PLANNING, ZONING, & BUILDING DEPARTMENT
PZ&B Staff Combination Memorandum: Architectural Commission and Town Council

SUBJECT: ZON-23-094 (ARC-23-121) 428 SEABREEZE AVE (COMBO)

MEETING: SEPTEMBER 27, 2023 | ARCOM
OCTOBER 11, 2023 | TOWN COUNCIL

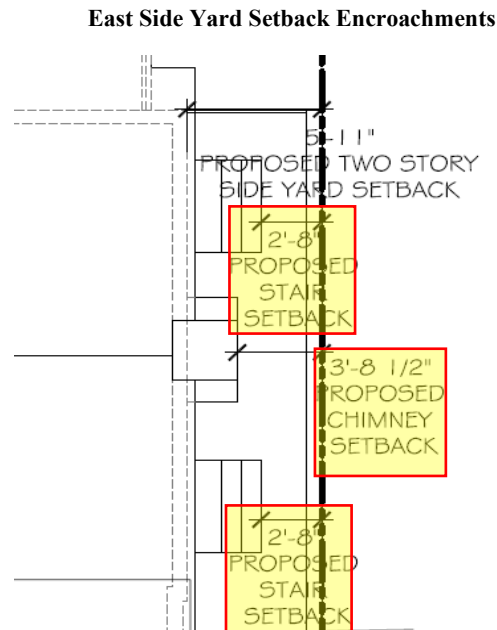
Analysis: The applicant has provided diagrammatic site plans on architectural plan sheets 5, 5A, and 5B. The sheet 5 diagrams illustrate that the footprint of the new residence will be constructed on substantially the same footprint as the existing residence. The proposed detached cabana will not occupy a similar footprint as the existing detached accessory structure but is compliant with current R-B zoning regulations. The diagram on sheet 5B graphically illustrates the areas of the new residence that encroach into the typical R-B setbacks, but that are on the same footprint as the existing building.

Per Criteria 3, no portion of the proposed residence's footprint shall encroach into an absolute minimum five-foot setback. Per the proposed site plans, the residence's habitable footprint does not encroach into a five-foot setback, but two sets of side entry steps and a chimney are proposed to encroach into the required east side yard. The two sets of steps have a proposed east property line setback of 2'-8" and the proposed chimney has an east property line setback of 3'-8 1/2".

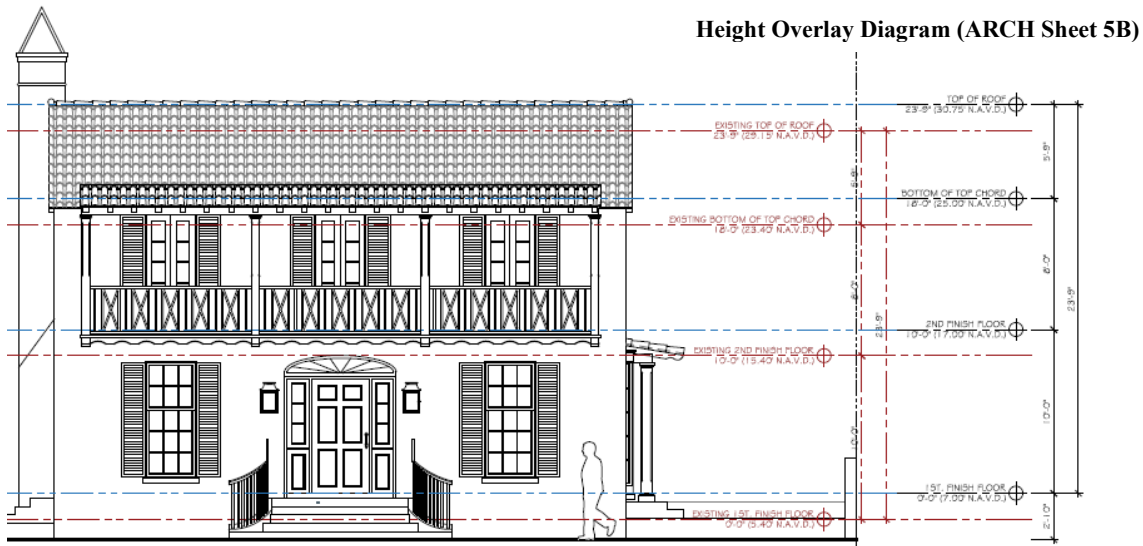
Analysis: The parcel lies within Flood Zone AE6, which requires new construction to build at a Finish Floor Elevation of 7’ NAVD, thus establishing the point of measurement at 7’ NAVD. The existing residence has a Finish Floor Elevation of 5.4’ NAVD.

A height overlay diagram provided on sheet 5B illustrates the points of measurement, building height (exterior wall height), and overall height (building height) for the existing and proposed residences. Per the graphic, the proposed residence’s height and overall height are proportionally the same as the existing residence when measured from their respective points of measurement:
